Access Compliance Report

Public Rights-of-Way

(Pedestrian Signals)

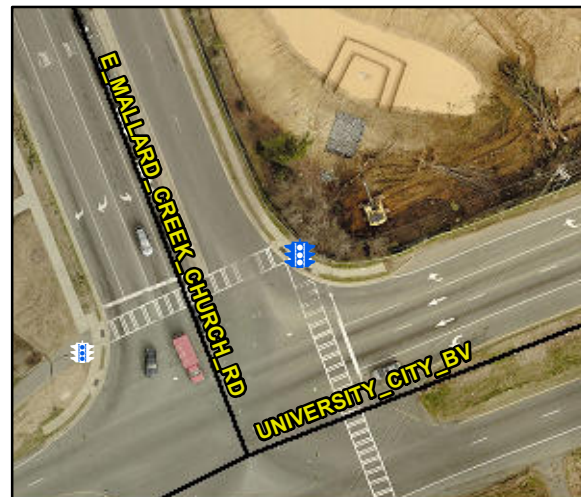
Surveyor Notes: N/A

N/A	B 1 Clear Xing Direction?	Yes	N/A	B 2 Clear Xing Direction?	N/A
	B 1 Crossing Direction	To SW		B 2 Crossing Direction	N/A
Yes	B 1 DistanceTo XWalk (in)	0.0	N/A	B 2 DistanceTo XWalk (in)	N/A
No	B 1 DistanceTo Curb (in)	87.0	N/A	B 2 DistanceTo Curb (in)	N/A
Yes	B 1 Diameter (in)	2.0	N/A	B 2 Diameter (in)	N/A

Possible Solutions: Replace Signal Push Button With APS Button on New Post. Remove & Relocate Sign.

PROW/ADA: TMUTCD 4e.08, R404.2, R404.7.2
